DAPHNE modifications for SoF receiver.

E. Cristaldo

October 12 , 2023

SoF Receiver – pinout 1st immediate batch

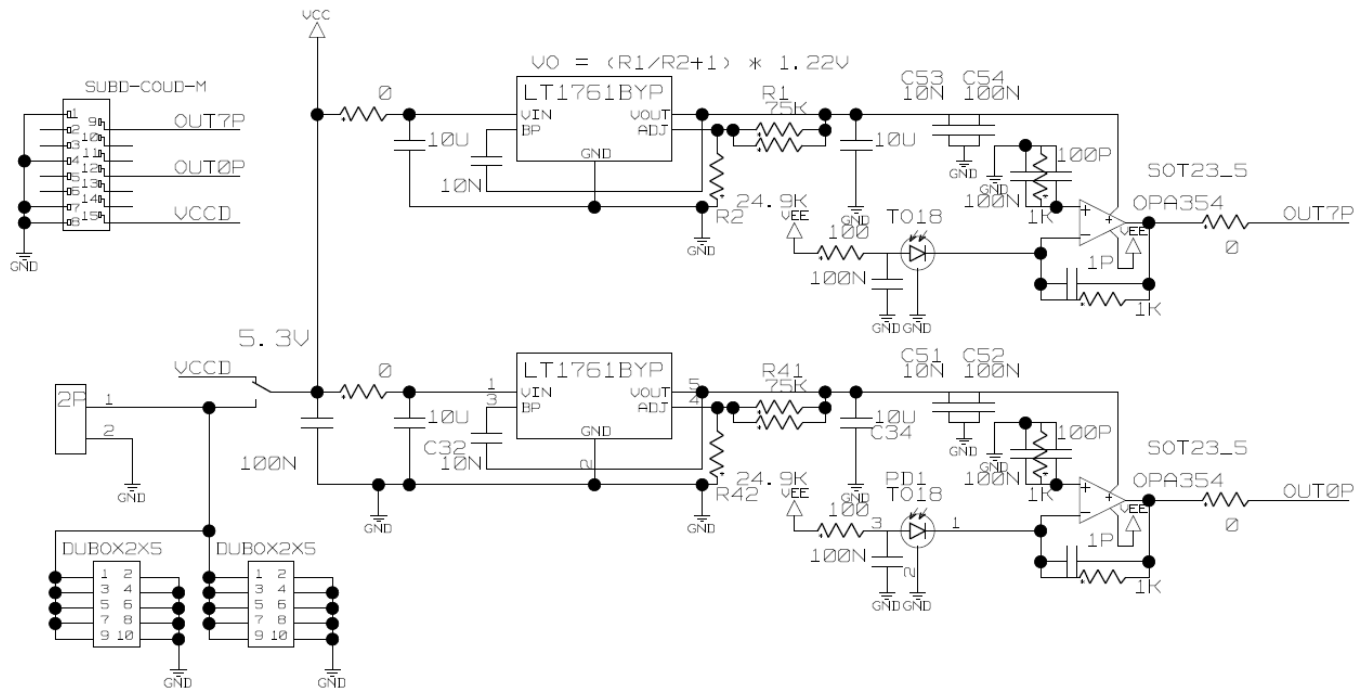
- 1) Gnd connection?
- 2) Signal: trim pins ?
- 3) Signal: Bias pins ?

1. GND (AGND): Pins 7 (7b*) and 8 (8b*) ; Pin 1 (Bias7_0) and Pin 4 (Bias2_0)
2. Signals: S1 → Pin 9 (Trim7_0) ; S2 → Pin 12 (Trim0_0).
3. VCC: Pin 15 (pin 15b*).
4. **All other pins must be left OPEN.**
5. **IMPORTANT:** Only one (1) (bottom) DB15 connector is necessary, pins must be left OPEN in the top DB15 connector if a double DB15 male connector is used.

*An exception can be made for (unused) pins 7b, 8b and 15b which can be tied with their corresponding analogues pins 7,8,15.

SoF Receiver - Power

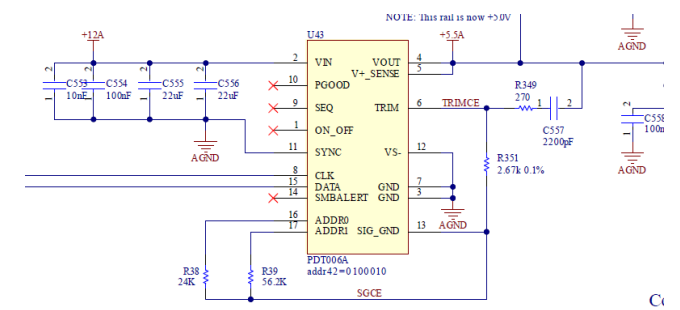
- SoF receiver is single ended output.
- 0 Ohm output resistor can be maintained or changed to 50Ohms.
- Required supply voltage is 5.3V.
- Power will be supplied by U43.
- Modification 1:
 - Change R351 to 2.55kΩ
 - Bypass power to pin 15.

SoF Receiver - Power

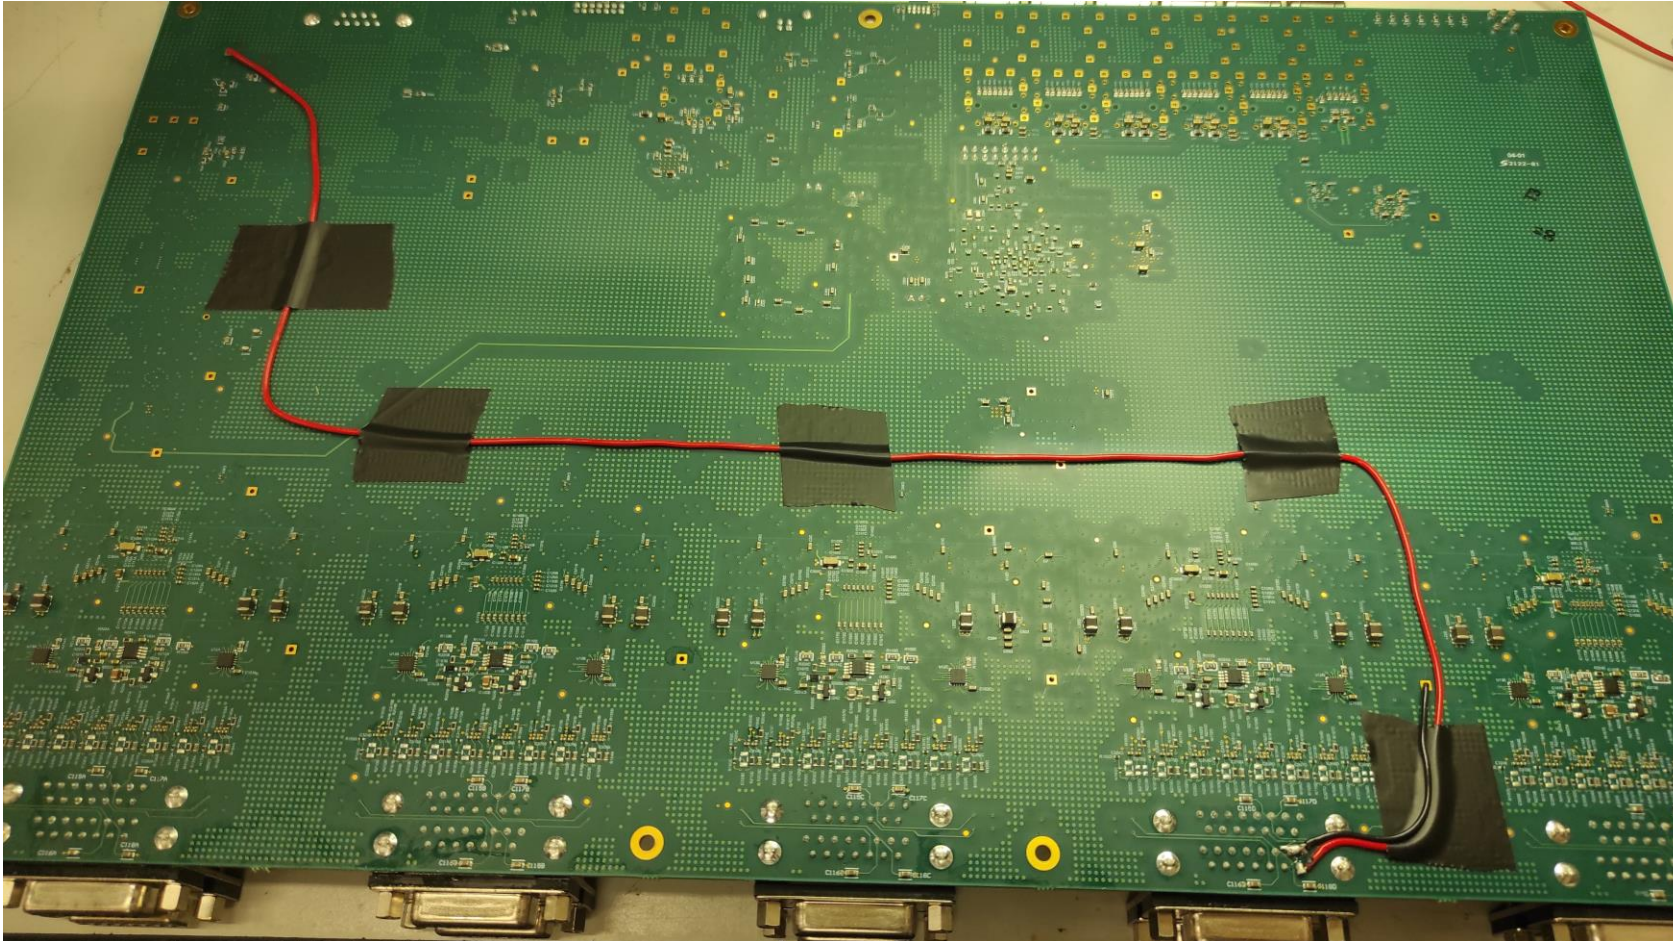
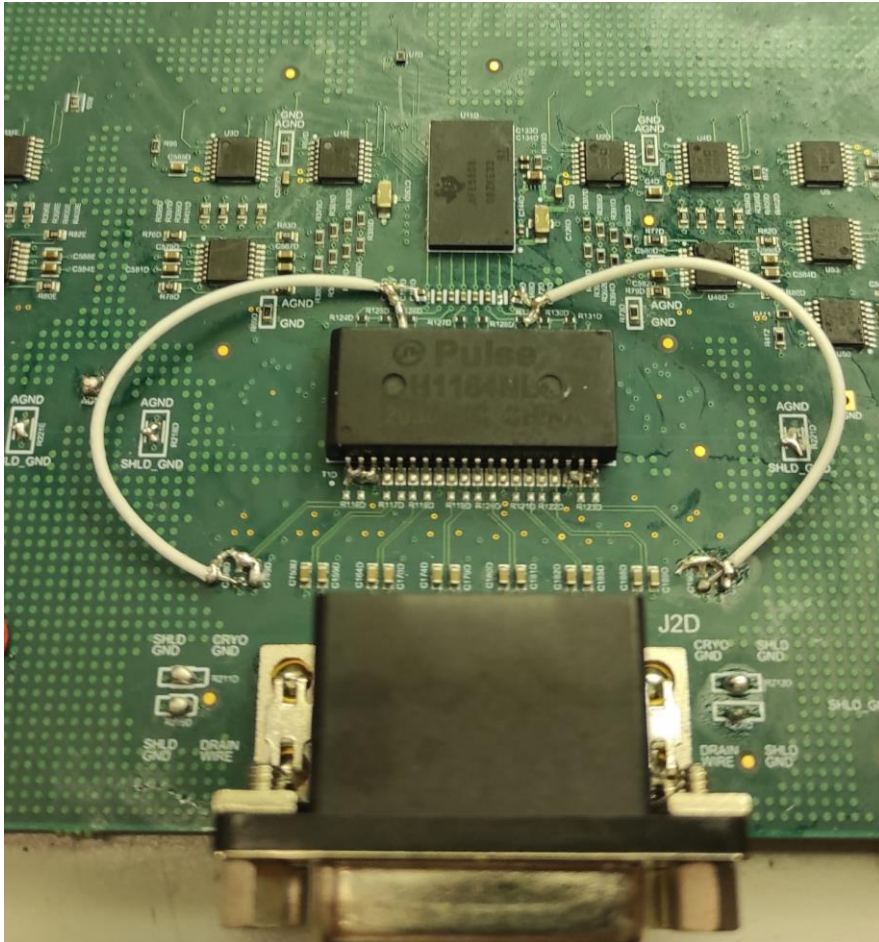
- **Red wire jumper** bypasses +5.5A test point to pin 15.
- Black jumpers bypass AGND to pin 7 and 8 to provide reference to the SoF Receiver Board.
- **The SoF has also has the possibility to be powered externally.**

SoF Receiver – Signal-Power modifications N°1 @ Milano-Bicocca

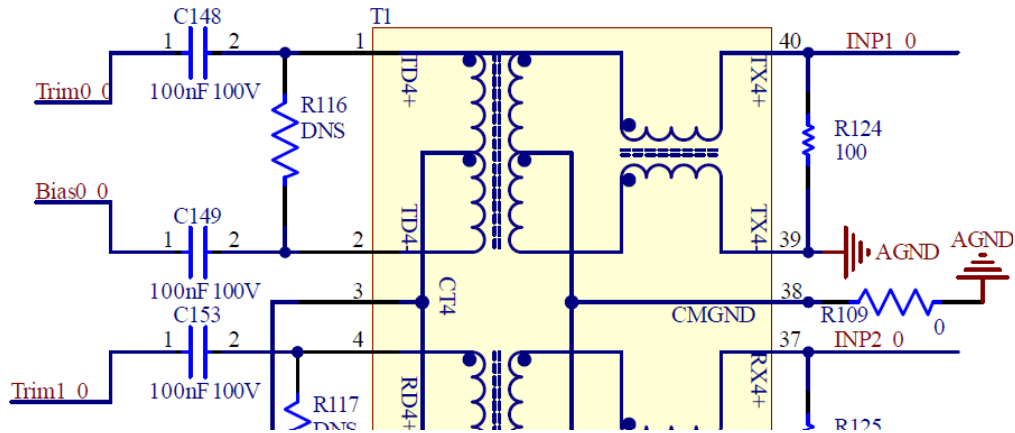
1. Removal of capacitors C148 (Trim0_0), C149 (Bias0_0), C190 (Trim7_0), C191 (Bias7_0).
2. Bias0_0 and Bias7_0 nodes connect to ground. Signals are injected through the Trim0_0 and Trim7_0 nodes.
3. Removal of resistors R184,R192 (Connection from Trim0_0 to current monitor) and R203,R210 (Connection from Trim7_0 to current monitor).
4. Disconnect C150 and C176, rotate 90 degrees and reconnect only pin2 of the capacitors, leaving pin1 floating.
5. Connect a 50 ohms resistor to pin1 of the capacitors in (4), ground the other pin of the resistor.
6. Bypass the transformer by shorting pad 1 of Trim0_0, Trim7_0 to the referred pin1 in (4)(5).
7. Change resistor R351 to 2.55K ohms to increase output of U43 from 5V to 5.3V.
8. Short rail name +5.5A (now 5.3V) to pin 15 of the DB15 connector.
9. Ground pin 7,8 of the DB15 connector.

Important: these modifications were done in this way in order to not damage the transformer in our daphne at Milano-Bicocca. I Do not recommend this modification for more than 2 channels per AFE

SoF Receiver – Signal-Power modifications N°2

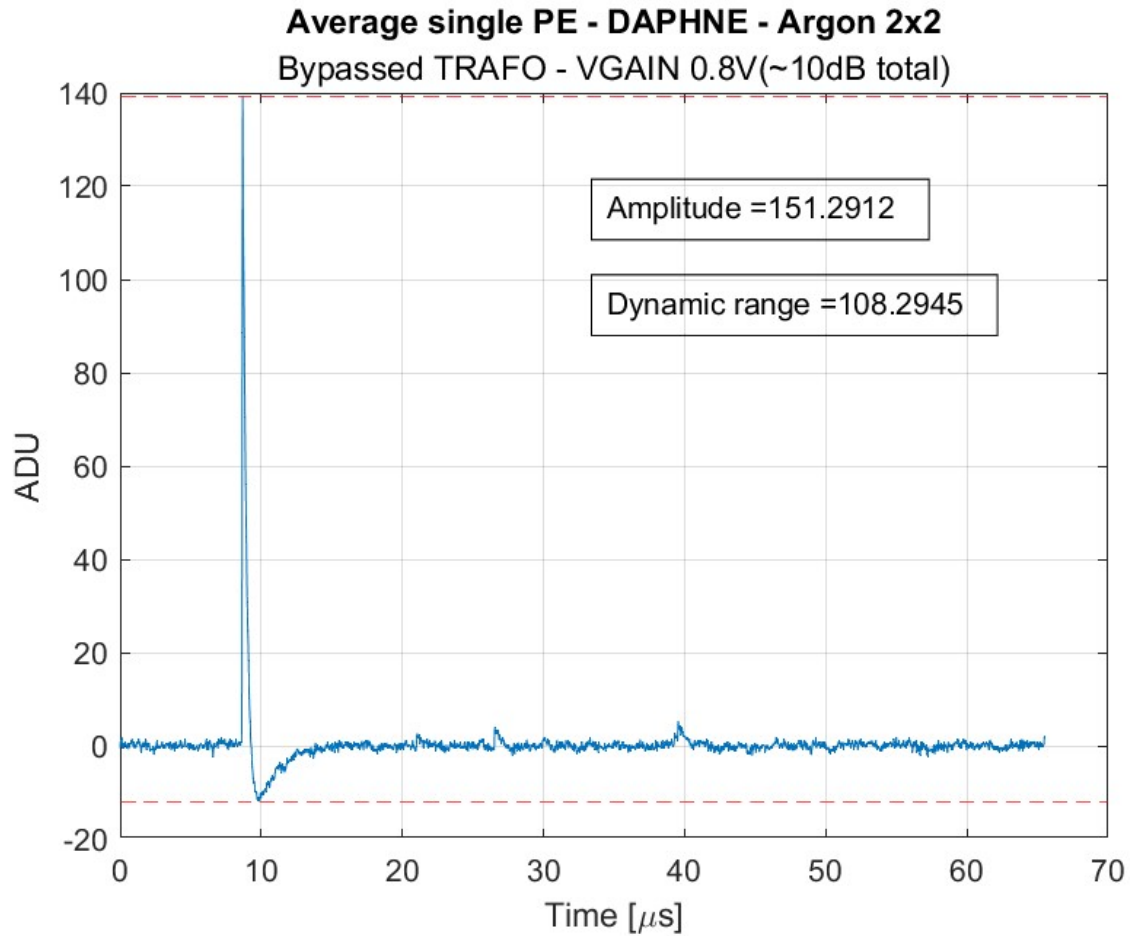
- From the previous slide list replace (4)(5)(6) with:
 - Remove transformer T1.
 - Short C148 pad1 and pad2; Short pin1 of T1 to pin 40. Short C190 pad1 and pad2. Short pin19 of T1 to pin 22.
 - Change R124,131 to 50 ohms (optional: leave the 100 ohms?).

Important: these modifications allows **all AFE input to be terminated directly**. Removal of transformer must be done carefully to prevent damaging pads. The transformer may have to be destroyed. Each DB15 could support 4 SoF channels, with 40 per DAPHNE in total.
